Access Compliance Report

Public Rights-of-Way

Intersection ID: 16868	Main Street: HASTINGS_DR	Cross Street: QUEENS_RD_WEST	Location: NE
ADA ID: 3CABC886E4E4	Ramp Type: BlendTrans1	Initial Pass/Fail: Fail	Overall Compliance: No
		Severity Score: 12.5

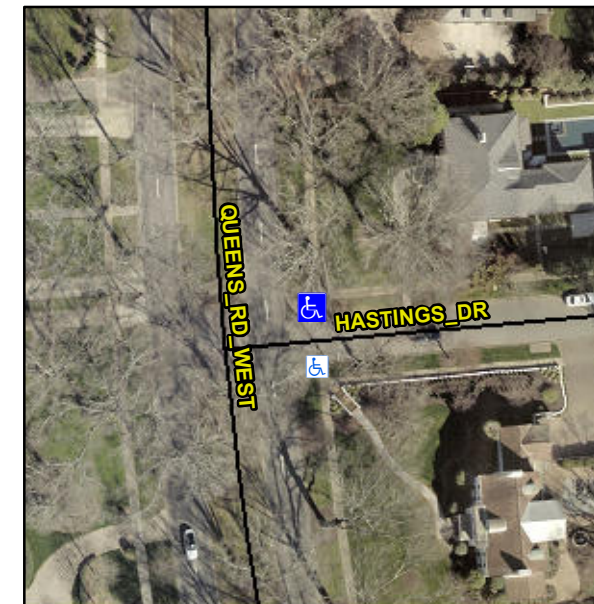
ASP LIP 1.0

R304.5.3

Compliance	Description	Data	Compliance	Description	Data
N/A	Ramp Length (in)	36.0	Yes	BlendTrans Slope (%)	4.6
Yes	Ramp Width (in)	60.0	No	BlendTrans XSlope (%)	5.7
N/A	Flare Type LT	N/A	N/A	Flare Type RT	N/A
N/A	Flare Slope LT (%)	N/A	N/A	Flare Slope RT (%)	N/A
N/A	Flare Traversable LT?	N/A	N/A	Flare Traversable RT?	N/A
N/A	Landing Length (in)	N/A	N/A	DWS Provided?	N/A
N/A	Landing Width (in)	N/A	N/A	DWS Contrast?	N/A
N/A	Landing Slope (%)	N/A	N/A	DWS Length (in)	N/A
N/A	Landing X Slope (%)	N/A	N/A	DWS Full Width?	N/A
N/A	Landing Curb? (Y/N)	N/A	N/A	DWS Offset (in)	N/A
N/A	Shared Landing?	N/A			
N/A	Gutter Ponding?	N/A	N/A	Gutter Slope (%)	N/A
N/A	Gutter Lip Ht (in)	N/A	N/A	Gutter X Slope (%)	N/A
N/A	Painted X Walk1?	No	N/A	Painted X Walk2?	N/A
	X Walk 1 Direction	To S		X Walk 2 Direction	N/A
	X Walk 1 Width (in)	N/A		X Walk 2 Width (in)	N/A
	X Walk 1 Slope (%)	4.9		X Walk 2 Slope (%)	N/A
	X Walk 1 X Slope (%)	4.3		X Walk 2 X Slope (%)	N/A

Remove & Replace Curb Ramp With Two New Directional Ramps or Equivalent.
